Our Ref: PL/26/0714
Your Ref:

6th July 2026

RE: PROPOSED WORKS TO 1NO. SILVER BIRCH TREE, 2NO. HIMALAYAN BIRCH TREES, 1NO. SYCAMORE TREE AND 1NO. MAPLE TREE AT 1 CHANDLER CLOSE, TILEHURST, READING - SUBJECT TO CONSERVATION AREA STATUS.

Figure 1: Sycamore - crown lift over the roof of the outbuilding in the neighbouring property

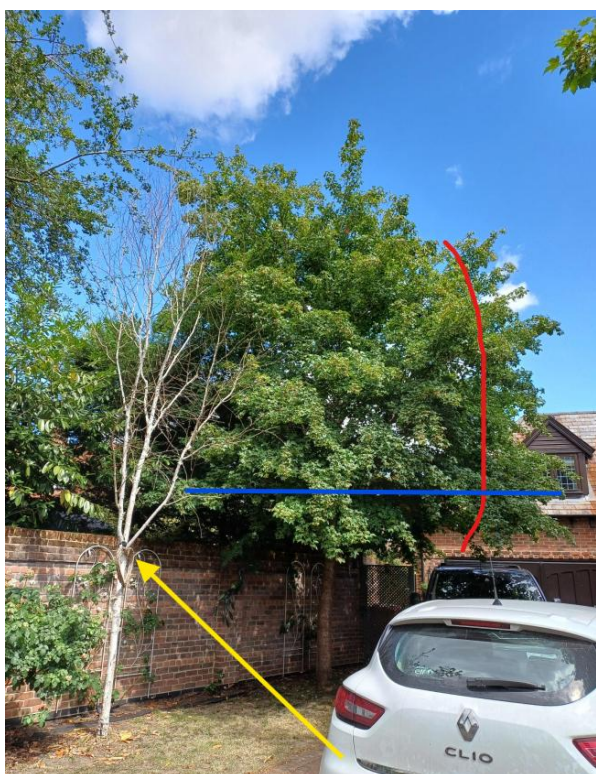
We agreed that the works to the Sycamore tree on the frontage were reasonable. The tree is of sub-optimal form, particularly with regards to the union between the two main stems, with its main trunk leaning towards the neighbouring property's boundary wall. As Sycamore trees have a large ultimate size potential, given it's setting, to manage its size we agreed the pollarding would be reasonable. We advised that you take your tree surgeons advice as to where suitable pollard points would be, with managing the weight load on said union in mind. We also advised crown lifting over the neighbouring property's outbuilding to create clearance would also be prudent as the branches are touching the roof, hence these have been included in the agreed works.

- Sycamore (front garden): pollard at suitable pollard points; crown lift to create 0.5-1m clearance above the outbuilding in the neighbouring property (see Figure 1).
- Himalayan Birch (front garden): fell to ground level (see Figure 2).
- Maple (front garden): tip reduce branches growing towards the driveway, as shown in Figure 2; crown lift over the driveway to create approximately 2.5-3m clearance above ground level as shown in Figure 2.
- Himalayan Birch (rear garden): crown lift, through 360°, to approximately 2.5m-3m above ground level (see Figure 3), including the removal of 1no. main branch back to source (see Figure 4) and other small diameter/minor growth back to source (see examples in Figure 5).

Figure 2: Himalayan Birch - fell (yellow arrow); Maple - crown lift (blue line) & tip reduction (red curve)

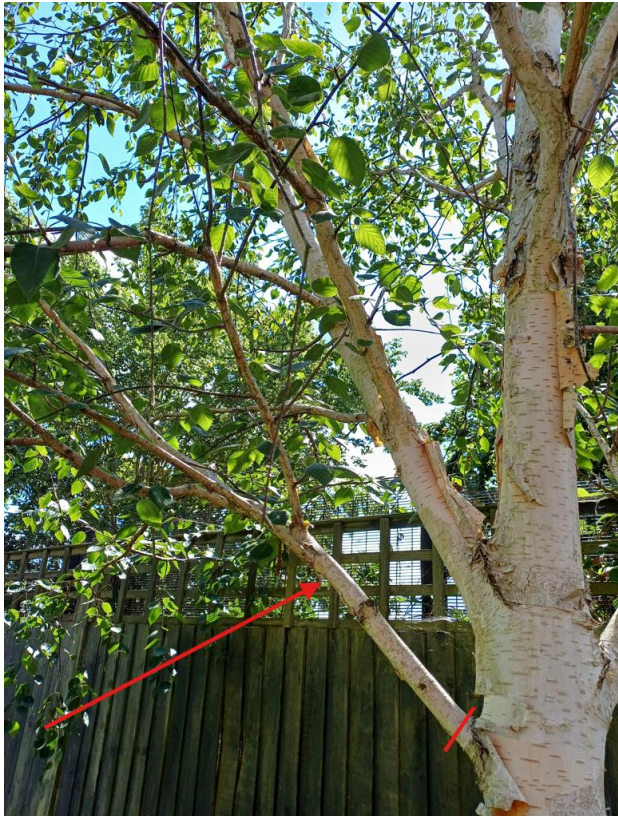
The felling of the Himalayan Birch on the frontage is agreed due to it being dead. As the tree is dead and within a Conservation Area, under Section 213 (1) of the Town and County Planning Act, a landowner has the duty to replant a replacement tree. If you wish to request that we waive this duty, please email us with reasons within 21 days of the date of this letter.

The original works to the Maple raised some concern about the impact on the tree's health and appearance. Originally, a significant height and lateral reduction was proposed. Your husband expressed that he didn't want the tree to get any bigger/taller. We advised that a Maple of this species wouldn't reach much taller in height than at the time of our visit, and such a significant reduction would encourage the rapid regeneration of new growth, which will be weakly attached and then requires repeat, ongoing pruning to contain its size. We also advised that this species does not resist decay well and it would substantially impact the tree's health. We came to an agreement that crown lifting and tip reducing the branches over the driveway to create clearance was reasonable as an alternative, and these are detailed in the works below.

Figure 4: Himialyan Birch - 1no. main branch to be removed back to source as part of crown lift

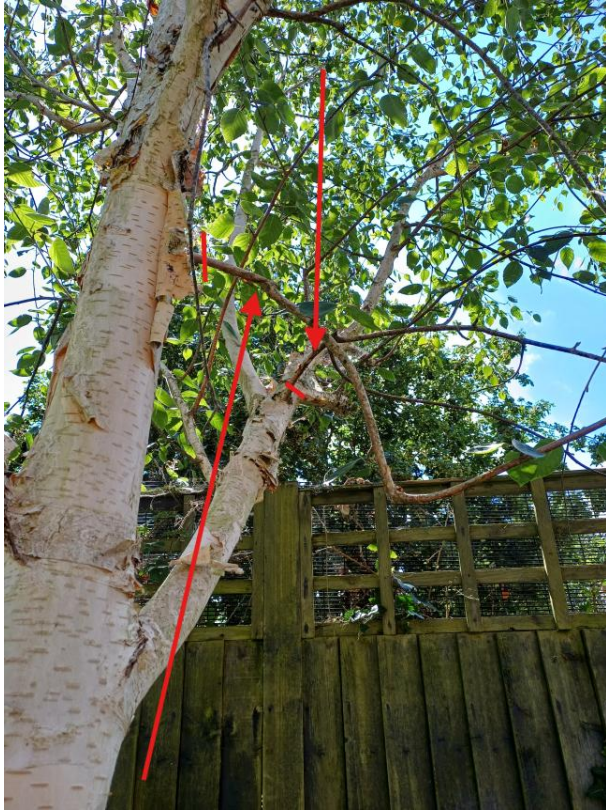
The Himalayan Birch in the rear garden originally was proposed for a '*trim*', with the annotated photograph provided indicating an overall crown reduction. We couldn't fully understand the purpose of the works; it doesn't cast significant shade and reducing it was advised against due to the resulting future maintenance burden and impact on the tree's health & appearance - the tree is currently young and of good form. We came to an agreement that crown lifting the tree would somewhat improve light availability, as an alternative, as further ground clearance will be created which we consider reasonable works given how low the branches currently are. As part of the crown lift, we agreed 1no. main branch could be removed back to source, along with other minor/small diameter branches, which are shown within the annotated photographs below.
